PENNY LANE II

LAND-2019-00399 & 00400

Site Plan Entitlement & Subdivision

Presentation Summary

Tree Exception

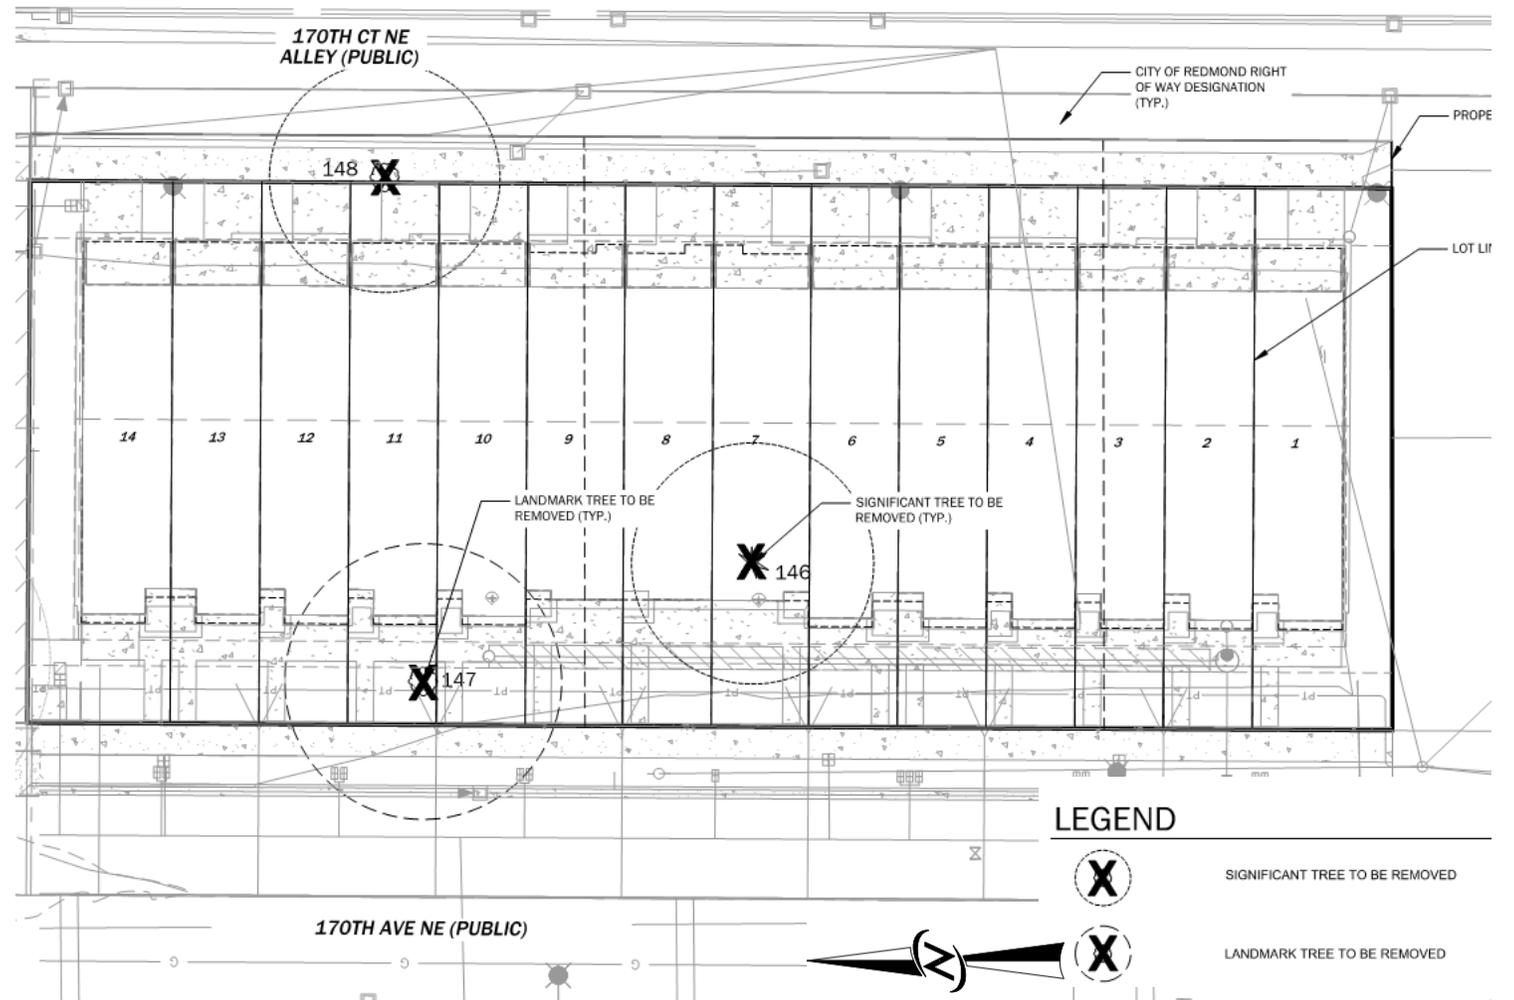
- Tree Exception Submitted RZC 21.72.090
- Planning Director Authority
- No trees retained (3 removed)
- Replacement at a 3:1 ratio required (9 trees required)
- 15 trees proposed
